Agenda Item #21 - Murphy Rd Subdivision 1-A-23-DP / 1-SB-23-C

Dear Commissioners,

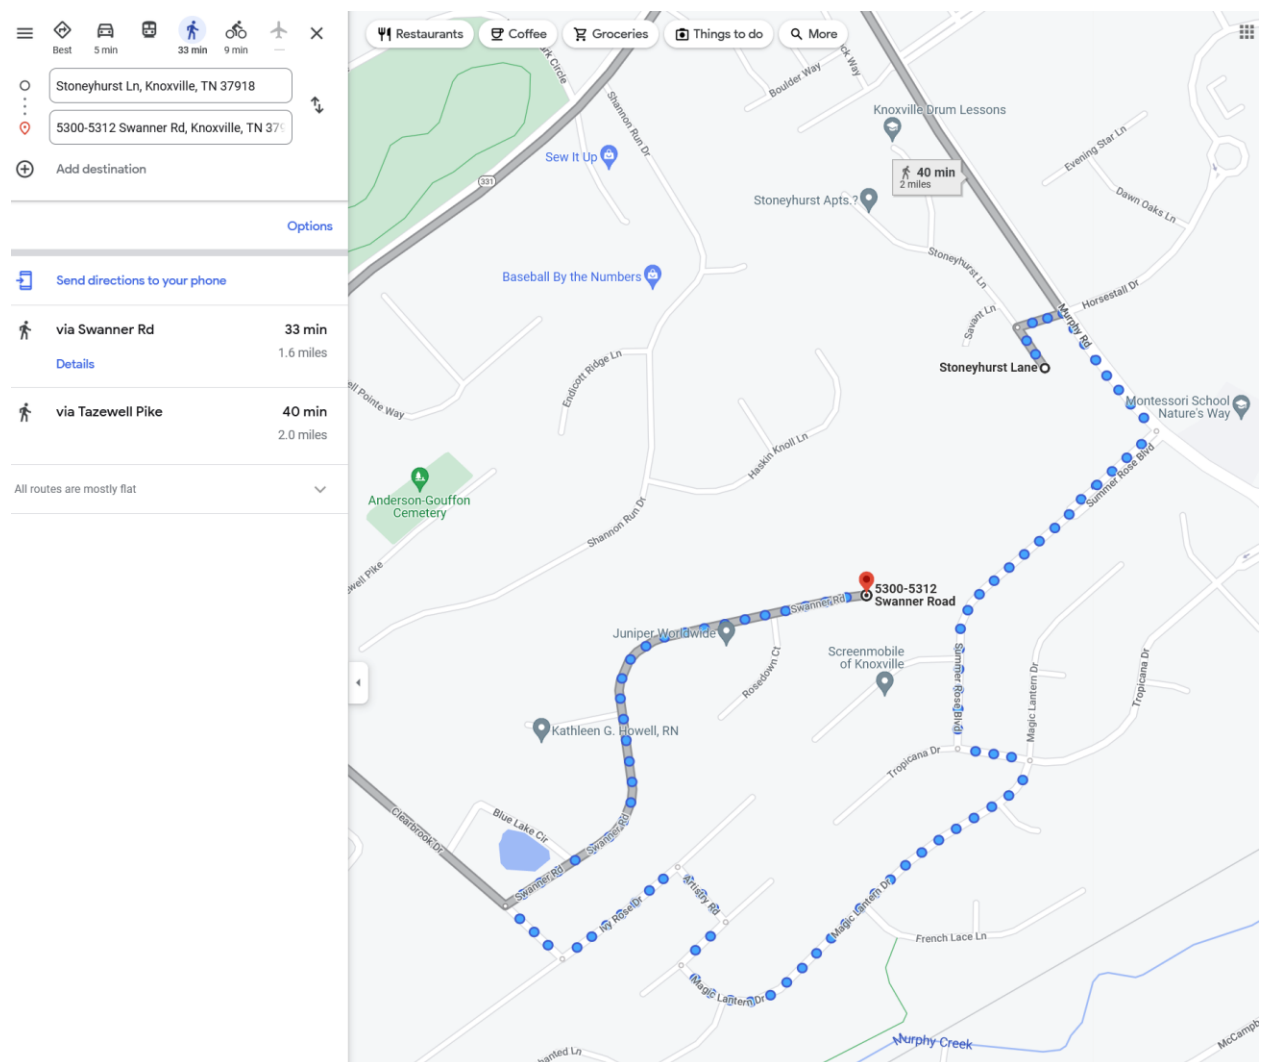
My March 2021 comments included the below map of farmland soils for the entire development. No soil conservation practices were required in the approval of Phase 1. 1-A-23-DP proposes grading and building on more “Prime if Drained” soil.

What can Planning Commission do to help conserve soils like this? This isn't an abstract idea. Page 28 of the Knoxville-Knox County General Plan identifies "Prime agricultural land should be protected for continued farm use". What do you have in your toolbox to guide developments to implement conservation principles?
